GENESEE COUNTY PLANNING BOARD REFERRALS NOTICE OF FINAL ACTION

T-04-BER-07-24

Site Plan Review and Area Variance for an Approx. 10,640 sq. ft. new commercial retail building (Dollar General) and associated site improvements on vacant land within Apple Tree Acres Business Park.

**RE: NEW 10,640 SF +/- COMMERCIAL RETAIL SPACE
INTERSECTION OF BUFFALO ROAD AND APPLE TREE AVENUE
PRELIMINARY SITE PLAN AND STORMWATER POLLUTION PREVENTION PLAN (SWPPP) REVIEW
MRB GROUP PROJECT NO. 0202.24000.000 – PHASE 007**

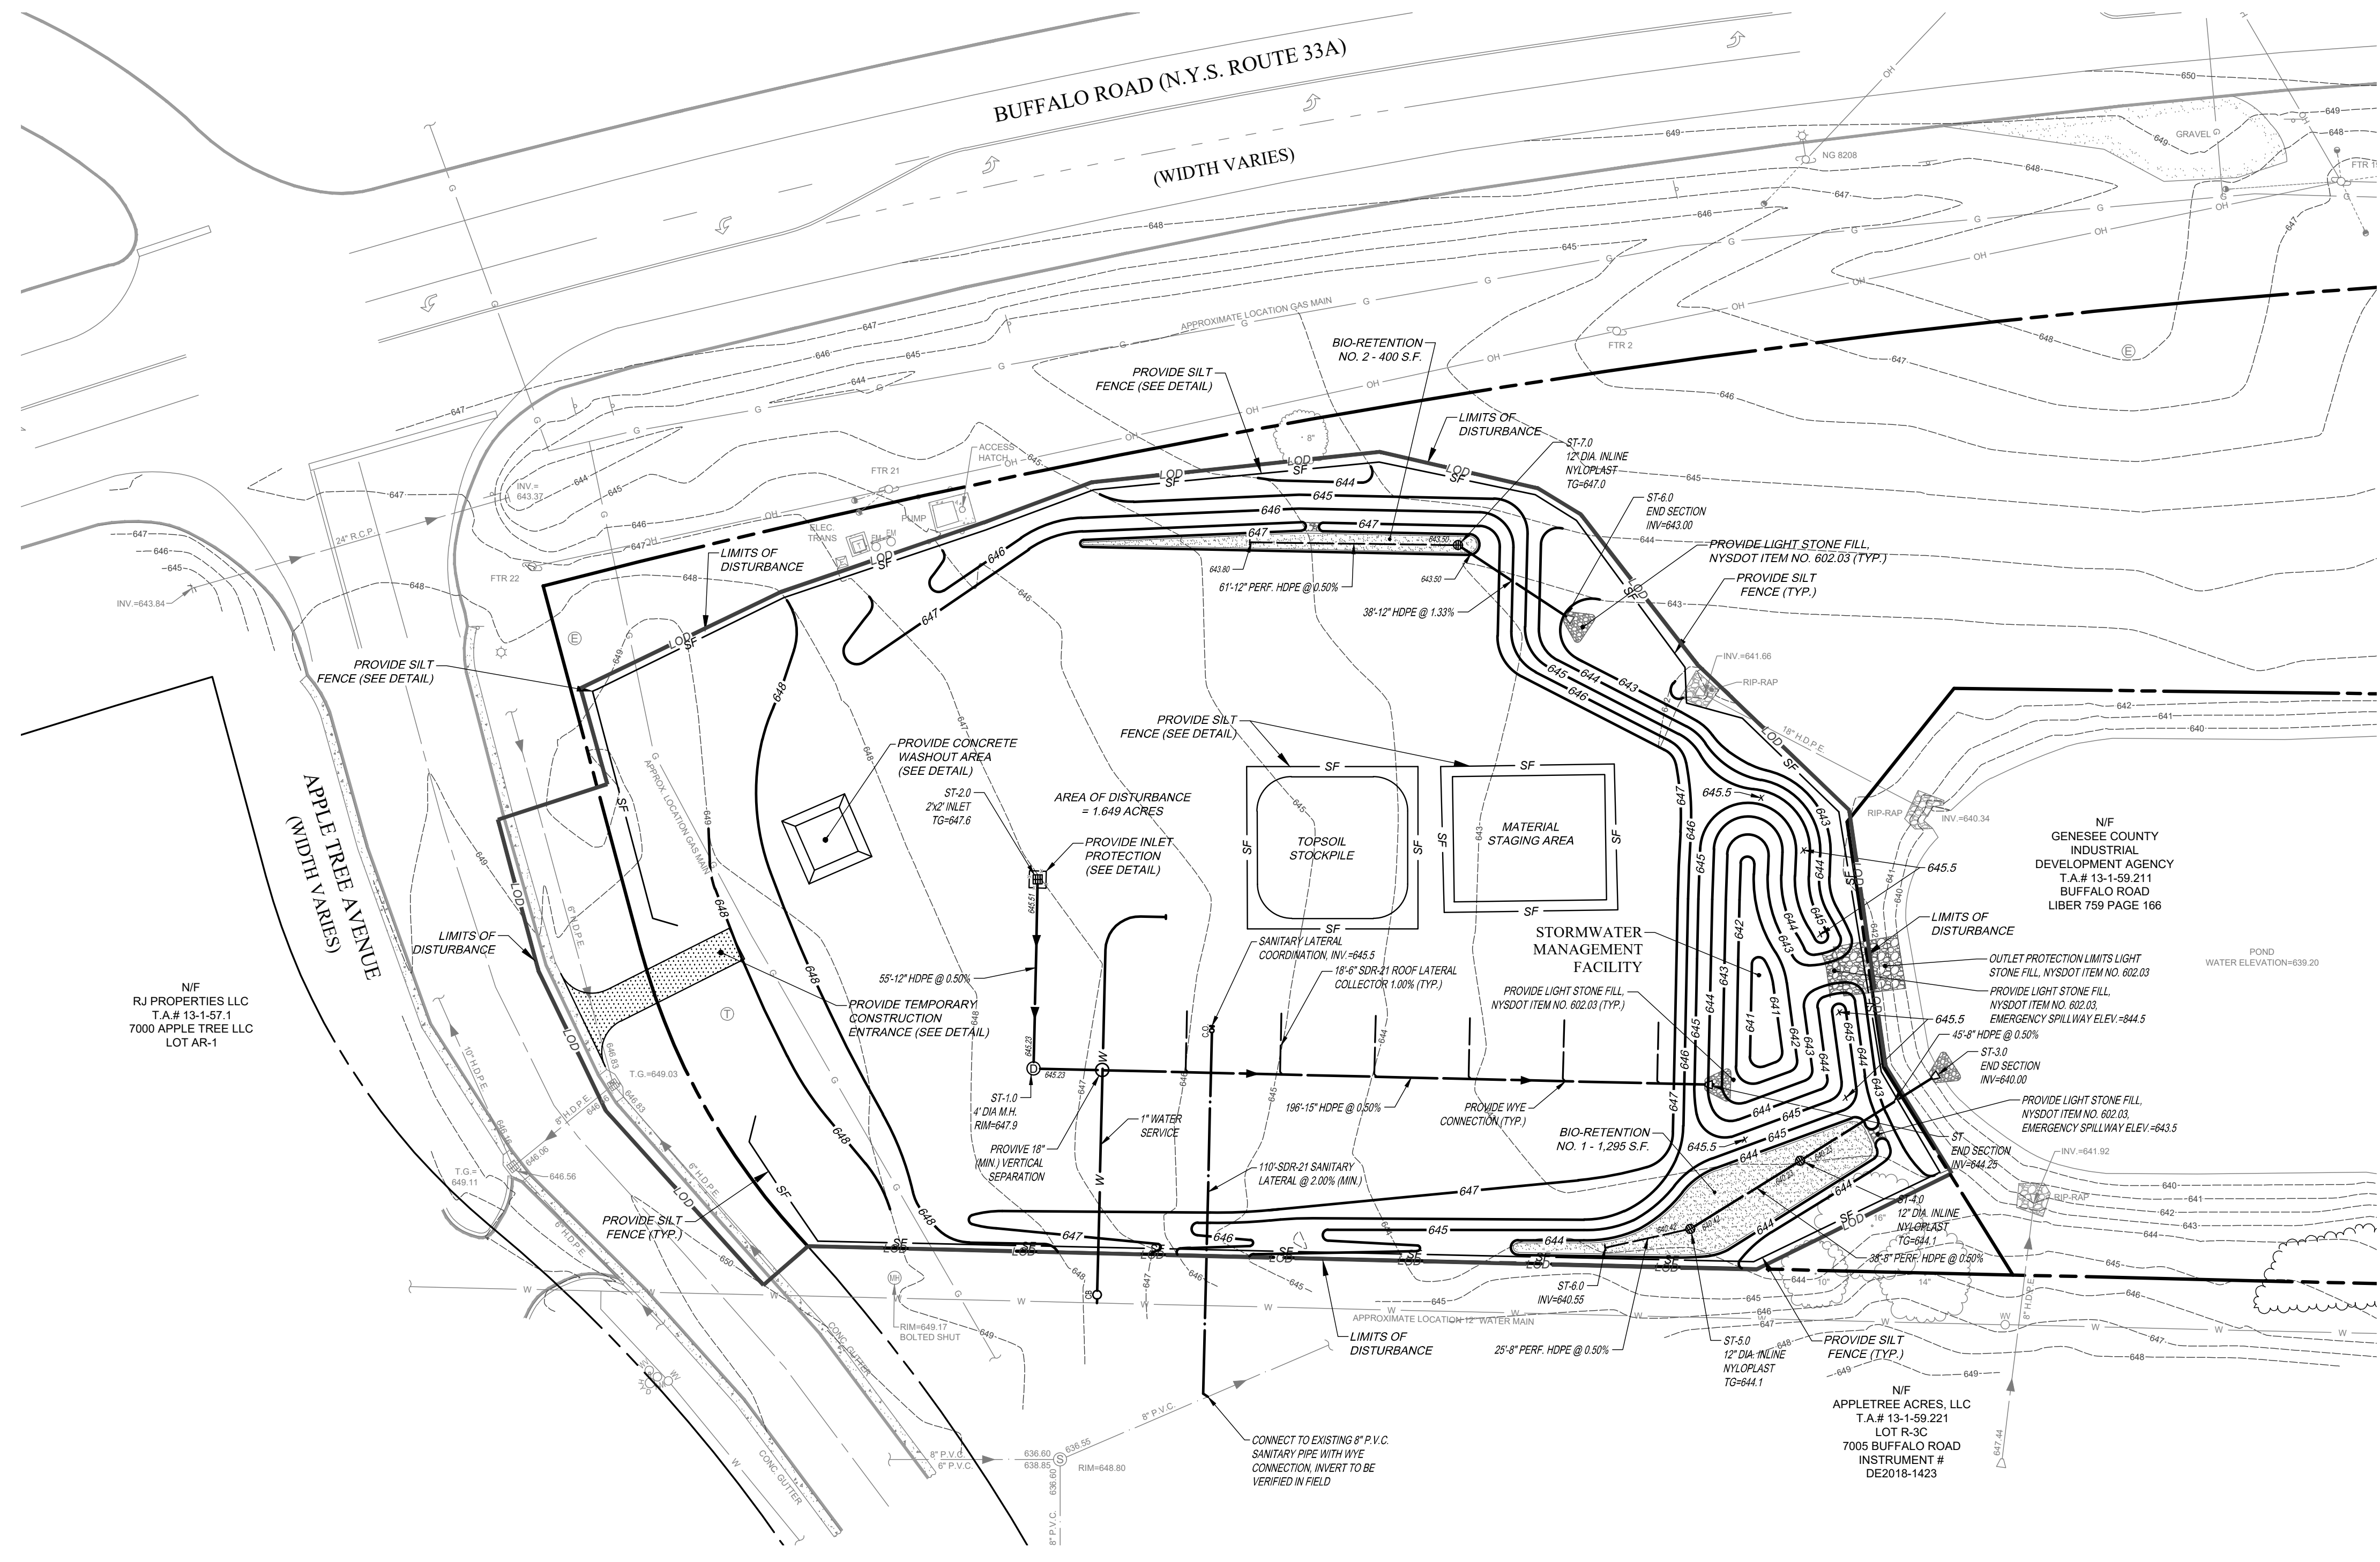
7. The following comments pertain to the Initial Phasing ESPC Plan (Sheet CE-130):
 - a. It is acknowledged that inlet protection was provided on some structures and a detail was provide as requested; however, all inlets should be shown provided with inlet protection (i.e. the catch basin south of the access drive is shown without protection).

6. The following comments pertain to the Initial Phasing ESPC Plan (Sheet CE-130):
 - a. All inlets should be provided with inlet protection from sediment runoff; please show on all inlets (i.e. catch basins, ST-2.0) and provide a detail.

DWG. # 8828
CA 150
SHEET 06 OF 15

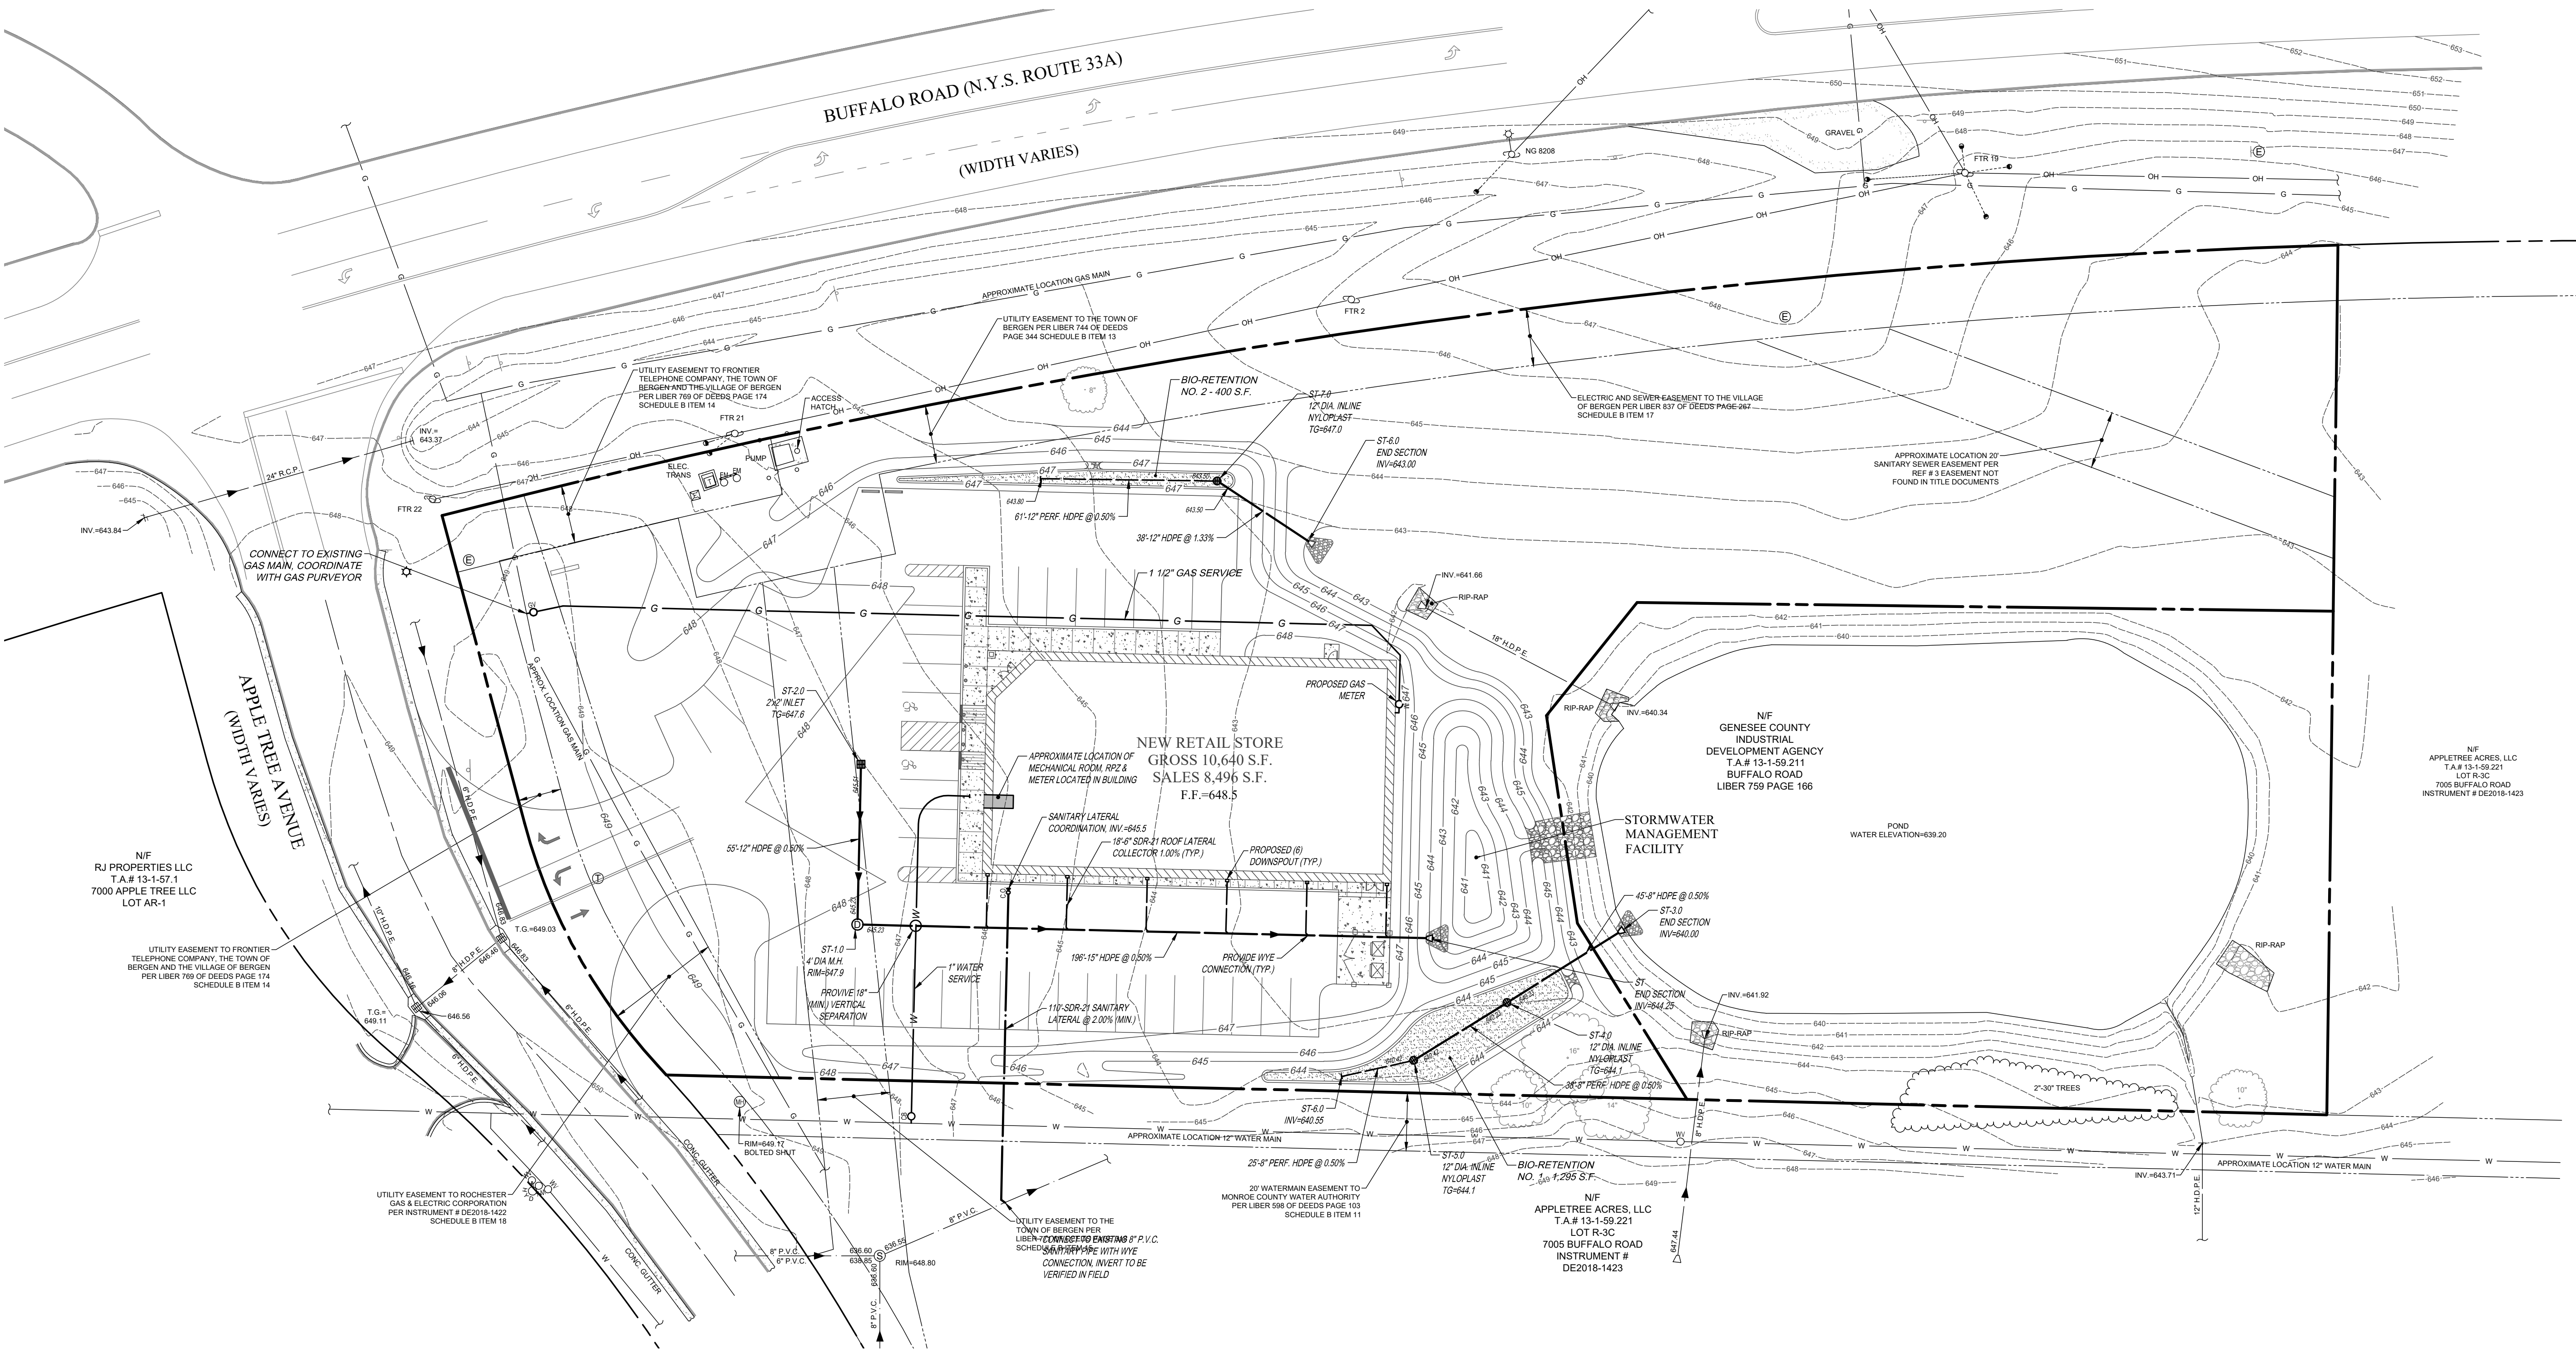
8. The following comments pertain to the Utility Plan (Sheet CA150)
 - a. It is acknowledged that a note was added to provide 18-inch vertical separation between the water line and the storm water/drainage piping; however, this should also be added for the separation between the sanitary sewer lateral and the water main. Water and sanitary sewer service sizing calculations and service installation details should be provided for review and approval by the Town Highway Superintendent.

7. The following comments pertain to the Utility Plan (Sheet CA150)
 - a. The proposed gas line and tie-in at the existing main should be labelled on the site plans and details should be provided.
 - b. Either a note should be added to the plans that states that a minimum clearance distance of 18" between the proposed sanitary sewer service and the water service shall be maintained or a profile view with proposed elevations showing the offset should be added.
 - c. Water and sanitary sewer service sizing calculations and service installation details should be provided for review and approval by the Town Highway Superintendent.
